ITEM III-B: DESIGN REVIEW PERMIT – 3975 DOUGLAS BOULEVARD – QUICK QUACK CAR WASH – PL14-0311

REQUEST

The applicant requests approval of a Design Review Permit for the purpose of removing all of the existing site improvements (landscaping, pavement, and an 1,880-square-foot building) and constructing a new automatic drive-through car wash and associated site improvements.

Figure 2: Internal Site Circulation Diagram

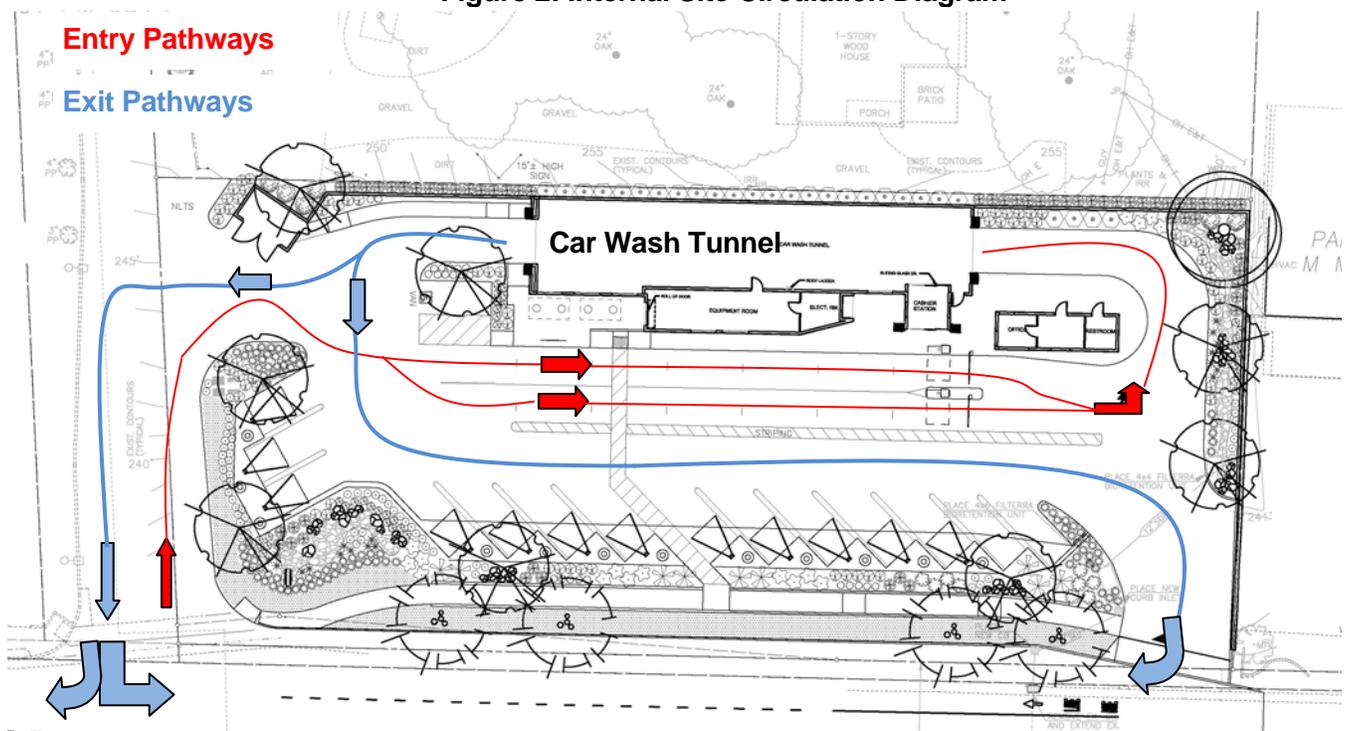
Access and Circulation: Refer to Figure 2 for the following discussion. The site frontage includes two driveways: one shared driveway at the western edge of the property and one unshared driveway at the eastern edge of the property. Douglas Boulevard is a six-lane facility in this location, and includes a protected left-turn pocket allowing entry into the western driveway. The eastern driveway is also full-access, but left turns are made from a center lane rather than a protected pocket.

The submitted site plan depicts the proposed circulation plan for the site. Vehicle entry will only be permitted at the western shared driveway, the throat of which will be reconfigured. In the existing condition, drivers entering the western driveway either continue going straight and into the parking lot for the office complex to the west, or turn right into an internal shared driveway serving both the project site and the site to the north. Drivers simply veer either right or left to access each property. To improve circulation, the applicant proposes to build separate entrances on the internal driveway for the subject property and the property to the north. A temporary construction easement over the property to the north will be needed in order to make this change. Cars will then be able to access the car wash site and drive straight ahead into the queue.

Vehicles exiting the car wash tunnel may either immediately exit the site via the western driveway or will drive down to the vacuum spaces. The vacuum spaces are located within a one-way drive-aisle which outlets at the eastern site driveway. This driveway will allow right-turn exiting vehicles only; no entrance

and no left turns will be permitted. Engineering has required this driveway to be sized to one-half the size of a standard driveway. The intent is to ultimately create a shared driveway that lies half on the subject property and half on the property to the east, with the full driveway width being completed at some point in the future when the property to the east is redeveloped. Engineering has determined that there are many driveways along this section of Douglas Boulevard which are too closely-spaced, and as properties redevelop—such as this one—some driveways will be eliminated and new shared driveways will be created. This will reduce the number of driveways on Douglas Boulevard and increase the distance between them.

Figure 4: Arch

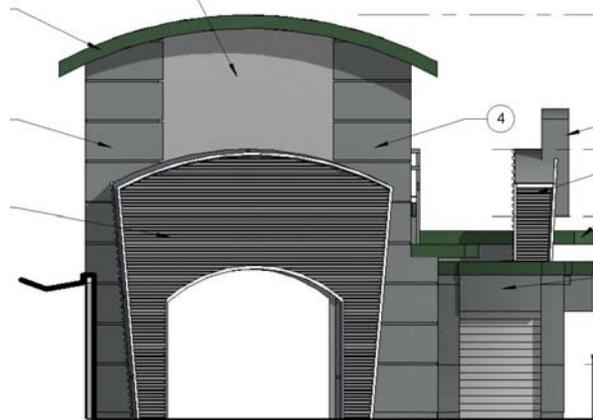
The proposed building includes variations in the rooflines, architectural treatments, colors, and materials, as recommended by the Community Design Guidelines. A four-color paint scheme is being used, including two grey tones, dark green, and off-white. The applicant has chosen a cool color palette that uses grey as the body color in order to visually connect with the office park to the west of the site. Materials used include cement plaster for the main body of the building, a standing seam metal roof, and a metal panel system for the arches. The roof will be green while the arches will be off-white. The western side of the building will include a taller element painted off-white, where signage is intended to be placed. This signage will need to be processed via a separate sign permit. In addition to the building itself, the project includes green shade canopies and round, decorative green trash cans at each vacuum space. Figure 3, Figure 4, and Figure 5 show examples of the building elevations and other site features.
